Revised Pad Size Re: NMSLO
request

From: Brian Wood <brian@permitswest.com>
Sent: Monday, December 30, 2019 11:47 AM
To: Rose-Coss, Dylan H, EMNRD
Cc: Blake Morphew
Subject: [EXT] BAM's Linley State SWD 1

LINLEY STATE 001H
Section 32 T15S R29E NMPM
Chaves County, NM

DWG. NO. : 11351-L01		REVISION: 2
DRAWN BY: H.J.	DATE DRAWN: 5/15/19	REV. DATE: 12/10/19
SURVEYED: 05/02/19	APP. BY: M.W.L.	SHEET: 1

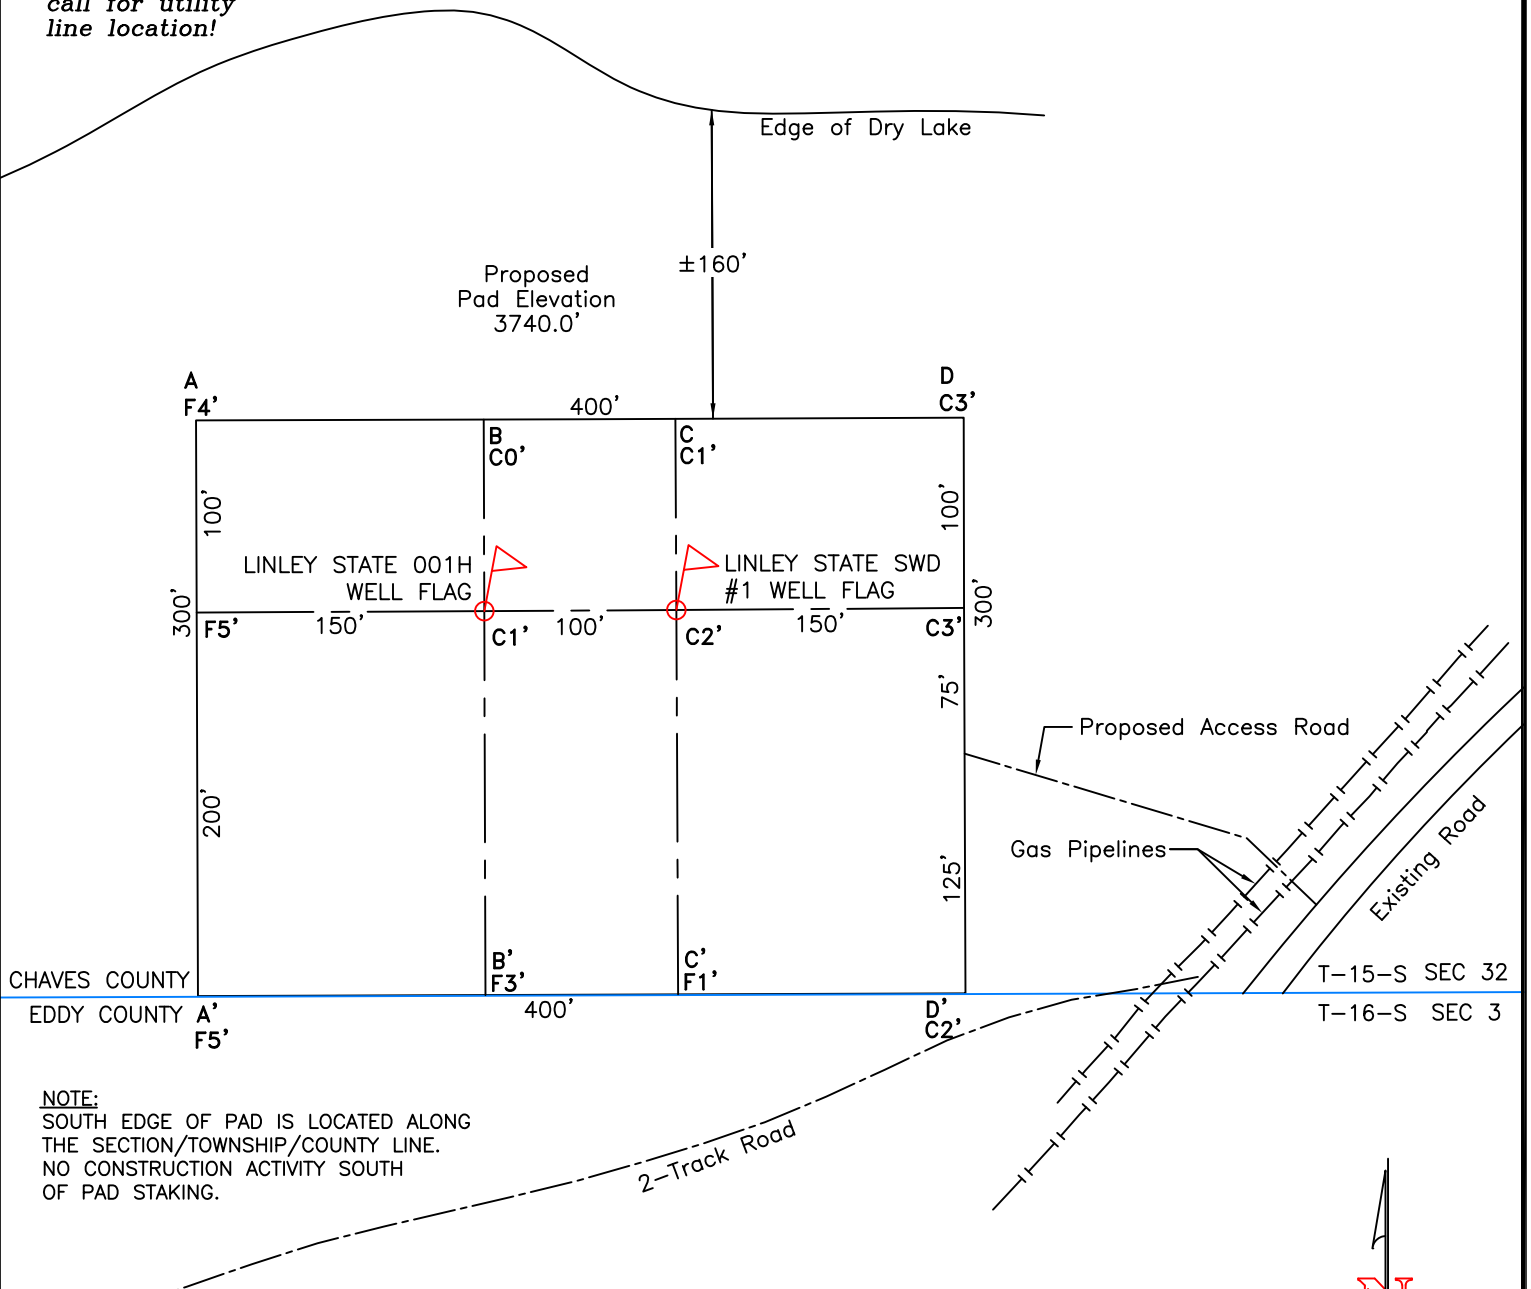
BAM trimmed 100' off north side of pad.
This reduced pad from 400' x 400' to 300' x 400'.

BAM shifted road south 75'.
The reduced length by 82.2'.

Does this resolve the NMSLO San Andres & topographic concerns?

Brian and Blake,
Yes the subsurface concerns highlighted by the SLO are resolved as well.

Thank you for your efforts. This re-stake will satisfy the State Land Office request for re-siting further back from the playa.
